WESTPORT
Planning & Zoning Commission-CAM
11.18.2024

14 Owenoke Park
Owenoke Park Partners LLC

Reviews

CAM Review Required:

Development Plan

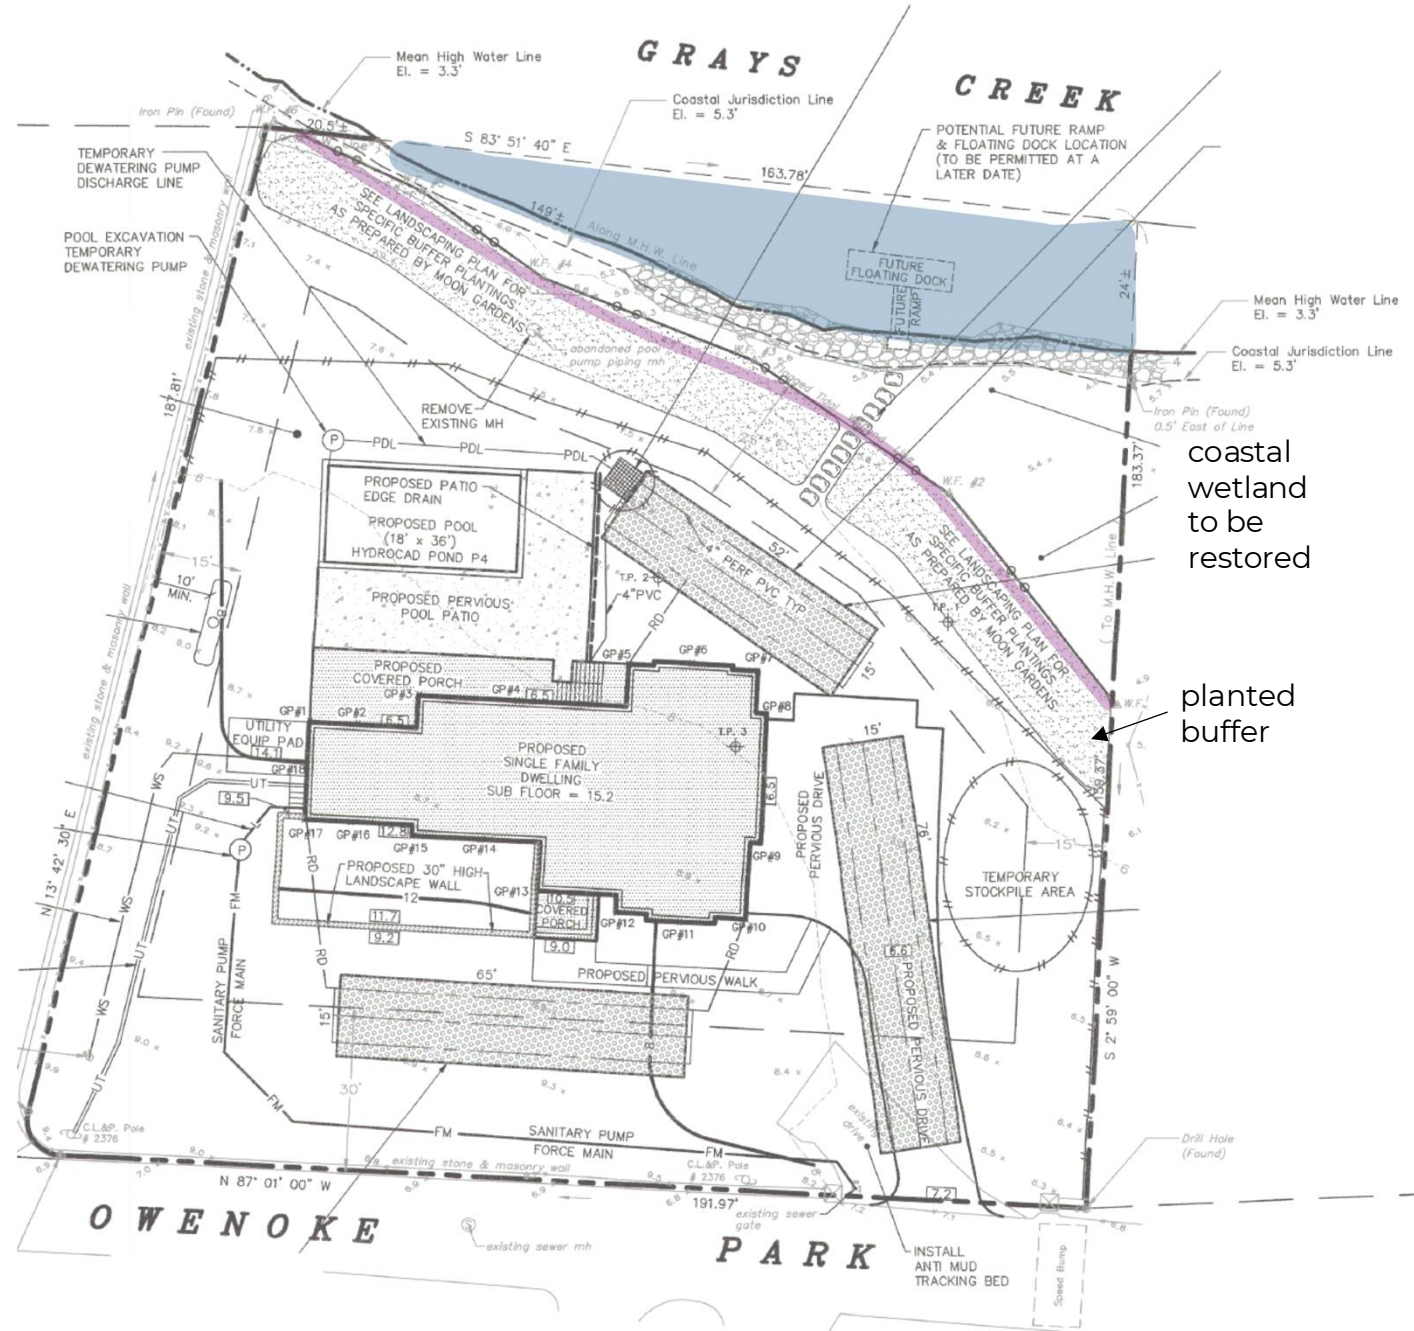
- Construct FEMA home @ 15.2' el. (AE 13)
- Using same entrance from Owenoke
- Pool (18' x 36')
- Install detention galleries (3) where no drainage existed previously
- Drainage system
- Pervious driveway, walks & patios
- 15' Planted buffer along resource
- Remove portion of lawn and rehabilitate coastal/tidal wetland
- Rip-rap wall to be legalized with DEEP permit (require removal of small stones)
- Total Coverage is compliant at 20.97%
- Meets applicable regulations of §13 (Res A) zone.
- Return to construct floating dock & ramp

1. Modify the building plans to provide adequate flood venting; and
2. Obtain final approval from the Engineering Department.
